We hereby inform you that the 10G cap has been changed.  
From now on all orders of 10G will be delivered in the new design.

Picture 1.

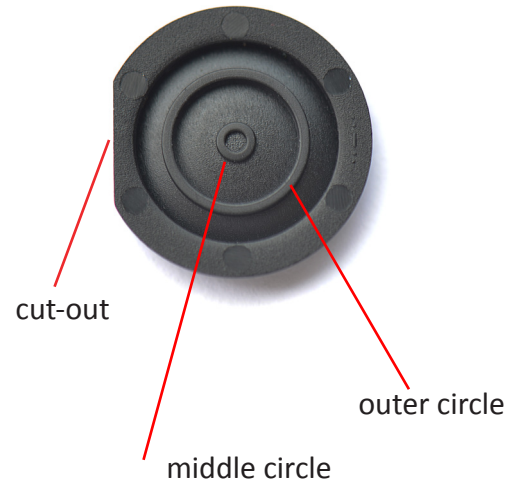
The circle in the middle of the back was added to provide a crisper sound and feel when using 10G cap with Ultramec 6C. The outer circle was added so that when the cap is pushed the circle will rest on top of the metal lid of the switch and provide protection against overtravel.

The cut-out was reduced to secure that when using the cap with LEDs on the PCB there is no illumination bleed in between the panel and the cap.
